From: Oswald, Hank
Sent: Monday, August 12, 2019 10:32 AM
To: 'competentb@gmail.com'
Subject: B19002442_11610 Johns Hopkins Road_Floor Plans/OSDS Plan
Attachments: Section 3.801 Bedroom Definition.pdf

Good morning. The floor plans for building permit # B19002442 (11610 Johns Hopkins Road) show 10 bedrooms and the OSDS Plan is sized for 9 bedrooms.

PROJECT:	AJ GILL PROPERTY JOHNS HOPKINS ROAD		
LOCATION:	TAX MAP: 41, GRID: 9, PARCEL: 259 ZONED: RR-DEO 5TH ELECTION DISTRICT HOWARD COUNTY, MD, TAX ID #05-351731		
TITLE:	BUILDING PERMIT PLAN		
HOUSE TYPE:	CUSTOM		
DATE:	JULY, 2019	PROJECT NO.:	2473
SCALE:	AS SHOWN	DRAWING	1 OF 4

PLAN VIEW
1" = 50'

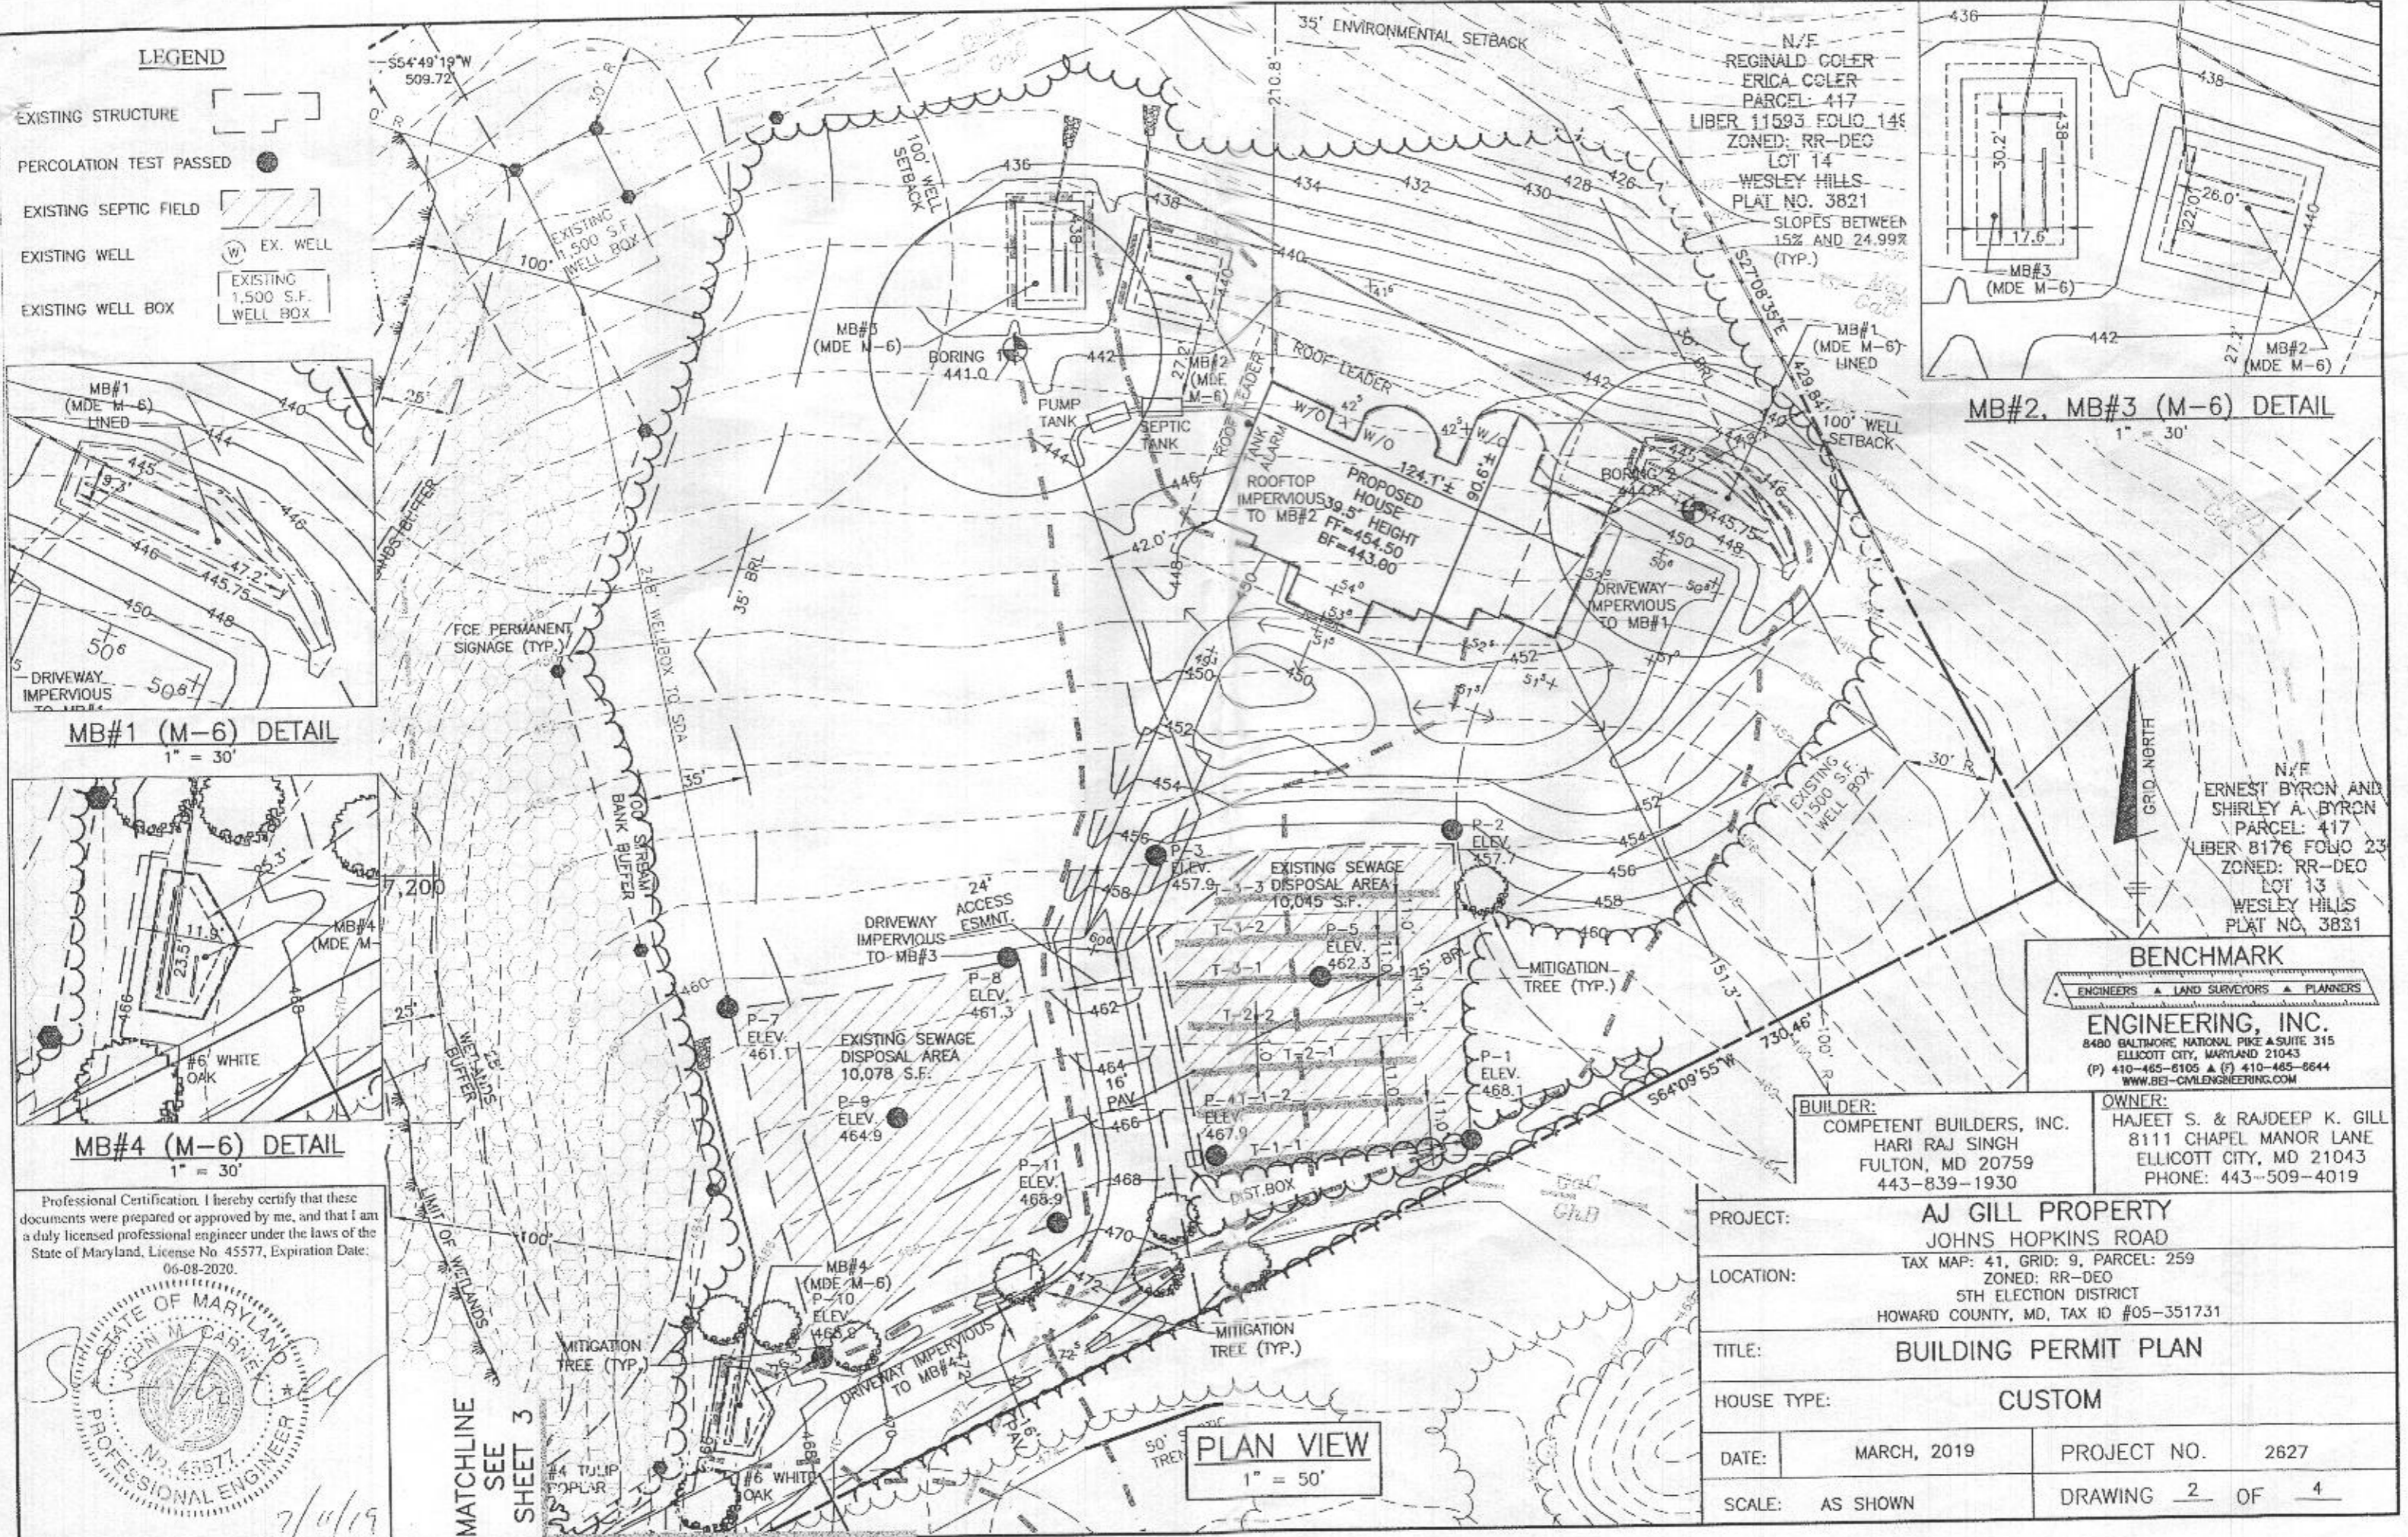
Basement – 3 bedrooms (Office, Guest Room and Gym Area)
1st Floor – (Guest Room 1 & 2)
2nd Floor – (Suite 1 thru 4 and Master Bedroom)

Please revise the floor plan or septic plan to match. Should you have any questions, please don't hesitate to ask.

The OSDS plan for this lot was submitted in July, but it does not include the variance condition requirements for a BAT unit and LPD drainfield. We will need the plan to be revised to include those items before we can approve a building permit. Thanks
Jeff
